## TOYOTA TACOMA

### OUTLINE OF NEW FEATURES

The following changes are made for the 2003 model year.

228TA03

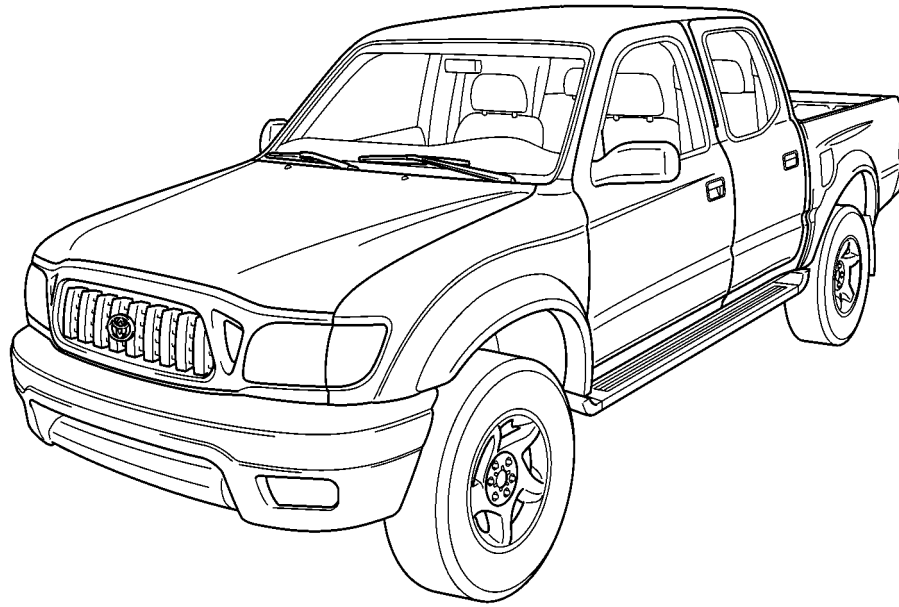
# TACOMA

#### 3. A340E and A340F Automatic Transmission

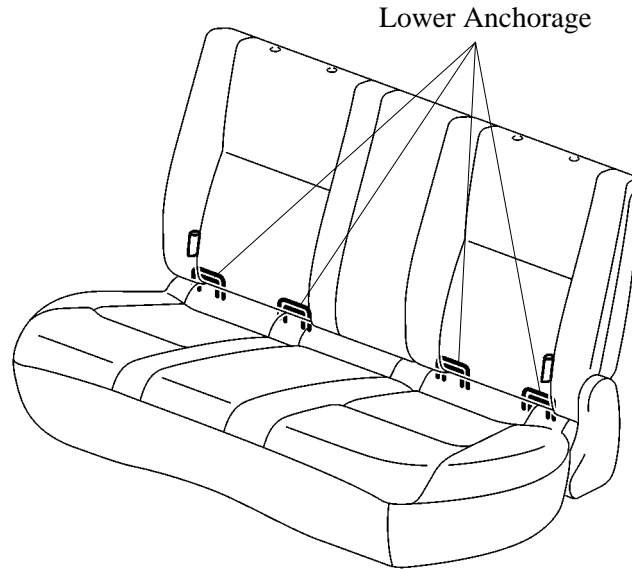
- The line pressure control using a linear solenoid valve (SLT), which was adopted on the '02 Toyota Tundra with the 2UZ-FE engine, has also been adopted on the '03 Toyota Tacoma with the 5VZ-FE engine. Accordingly, the shape of the valve body and the logic of the ECM have been changed.
- The previous mechanical control, which consisted of a throttle cable, cam, and throttle valve, has been changed to an electronic control system that uses a solenoid valve SLT.
- The automatic transmission fluid of 3RZ-FE and 5VZ-FE engine model has been changed from the D-II type ATF to the T-IV type ATF.
